# Access Compliance Report

## Public Rights-of-Way

Intersection ID: 27328	Main Street: SPICE_HOLLOW_CT	Cross Street: STANETTE_DR	Location: SE
ADA ID: 54EA9DD025C7	Ramp Type: PerpDiag	Initial Pass/Fail: Fail	Overall Compliance: No
		Severity Score: 10

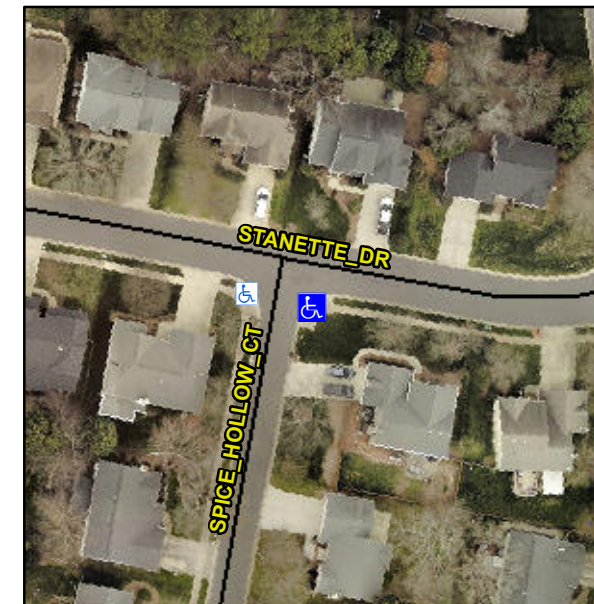
**R304.5.1, R304.5.3**

Compliance	Description	Data	Compliance	Description	Data
N/A	Ramp Length (in)	96.0	Yes	Ramp Slope (%)	7.4
No	Ramp Width (in)	46.0	No	Ramp XSlope (%)	3.3
N/A	Flare Type LT	N/A	N/A	Flare Type RT	N/A
N/A	Flare Slope LT (%)	N/A	N/A	Flare Slope RT (%)	N/A
N/A	Flare Traversable LT?	N/A	N/A	Flare Traversable RT?	N/A
N/A	Landing Length (in)	N/A	N/A	DWS Provided?	N/A
N/A	Landing Width (in)	N/A	N/A	DWS Contrast?	N/A
N/A	Landing Slope (%)	N/A	N/A	DWS Length (in)	N/A
N/A	Landing X Slope (%)	N/A	N/A	DWS Full Width?	N/A
N/A	Landing Curb? (Y/N)	N/A	N/A	DWS Offset (in)	N/A
N/A	Shared Landing?	N/A			
N/A	Gutter Ponding?	N/A	N/A	Gutter Slope (%)	N/A
N/A	Gutter Lip Ht (in)	N/A	N/A	Gutter X Slope (%)	N/A
N/A	Painted X Walk1?	No	N/A	Painted X Walk2?	No
	X Walk 1 Direction	To NE		X Walk 2 Direction	To NW
N/A	X Walk 1 Width (in)	N/A	N/A	X Walk 2 Width (in)	N/A
	X Walk 1 Slope (%)	6.5		X Walk 2 Slope (%)	0.1
	X Walk 1 X Slope (%)	0.4		X Walk 2 X Slope (%)	5.2

**Remove & Replace Curb Ramp With Two New Directional Ramps or Equivalent.**
